## PLAN REVIEW SHEET

<b>Date:</b>	11/07/2007	<b>Staff Contact:</b>	David McDonald
<b>Petitioner:</b>	Northlake Pavillion LLC	<b>Telephone:</b>	704-336-6900
<b>Petition:</b>	2008-001	<b>Fax:</b>	704-432-1277
		<b>Email:</b>	<a href="mailto:dmcDonald@ci.charlotte.nc.us">dmcDonald@ci.charlotte.nc.us</a>
<b>Location:</b>	+/- 6.38 acres, Southeast corner Metromont Parkway and Statesville Road	<b>Attachments:</b>	Shelter_Concrete_Standards.pdf (See 60.01A)
<b>Existing Zoning:</b>	I-2 (General Industrial)		
<b>Requested Zoning:</b>	I-1 (Light Industrial) (Allow for additional uses on the site not permitted in I-2)

#### *FIRST SUBMITTAL*

CATS acknowledges receipt of the rezoning application and submits the following to the petitioner:

**WAITING PAD ONLY  
WITH PLANTING STRIP**

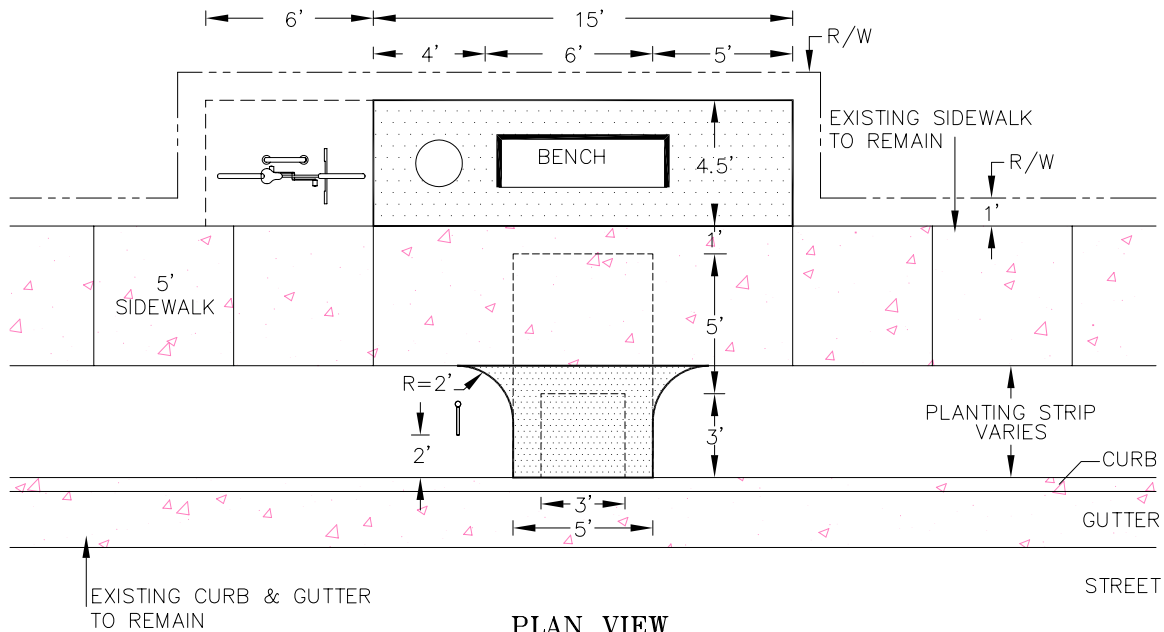
- 3) CATS additionally requests the petitioner to construct a waiting pad at the location of the existing bus stop on Statesville Ave. (Transit Stop ID #45854), constructed to CATS Development Standards 60.01 A (see attached).

- A waiting pad is the connecting piece of concrete which is installed from the back of curb through the planting strip to the sidewalk (see attached). The waiting pad provides an ADA accessible bus stop boarding/alighting location for CATS' passengers.

Please designate such in the site plan and/or accompanying notes. Please contact Leonard Ganther (CATS Operations) @ 704.432.1283 prior to demolition or construction, to coordinate any temporary relocation of the existing bus stop and to coordinate the final location of the new waiting pad.
